Item ID: D412-698-028

Item Name: Bracket, Aluminum Door RH

DART SERVICE INSTRUCTION

TO AMEND INSTALLATION INSTRUCTIONS IIN-D412-698 REV. E OR LATER APPROVED REVISION
AND ICA-D412-698 REV. 5 OR LATER APPROVED REVISION

FIGURE 1: D3199-3/-4 BRACKET INSTALLATION ON ALUMINUM DOORS
(-4 SHOWN, -3 OPPOSITE)

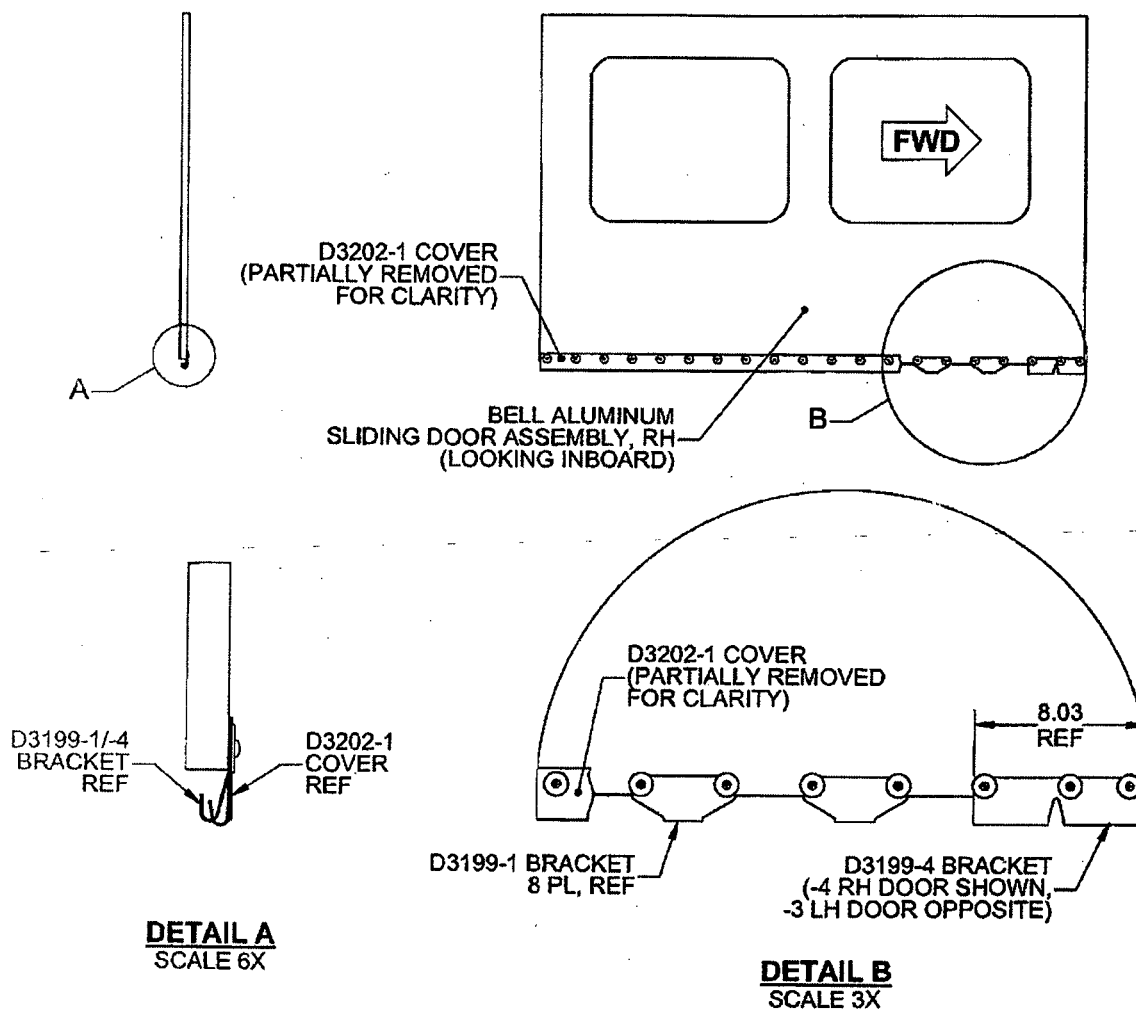
Field experience has shown that the forward D3199-1 brackets that are part of the D412-698-011/-012/-017 Cabin Door Roller Kits and forward D3675-1 brackets that are part of the D412-698-031/-032/-033 Cabin Door Roller Kits may wear prematurely if the aircraft is flown a significant amount of time with the sliding doors open. Dart has developed the D412-698-027/-028 kits that includes a longer D3199-3/-4 bracket for installation in the first forward position of the D412-698-011/-012/-017 kits to reduce wear on these forward brackets on aircraft equipped with aluminum doors. Likewise, Dart has developed the D412-698-037/-038 kits that includes a longer D3675-5/-6 bracket for installation in the first forward position of the D412-698-031/-032/-033 kits to reduce wear on these forward brackets on aircraft equipped with composite doors.

- 1) Remove the sliding door from the aircraft per Section 52.1 of ICA-D412-698
- 2) Remove the first forward D3199-1 or D3675-1 brackets as applicable.
- 3) Install the D3199-3/-4 or D3675-5/-6 bracket as applicable in lieu of the removed -1 bracket.
Refer to Figure 1 Sheet 2 (aluminum doors) or Figure 2 Sheet 3 (composite doors).
- 4) Torque hardware per ICA-D412-698.
- 5) Re-install sliding door on aircraft per Section 52.2/52.3 of ICA-D412-698 as applicable.
- 6) Make entry in technical records of aircraft indicating that DSI 9484 has been completed.
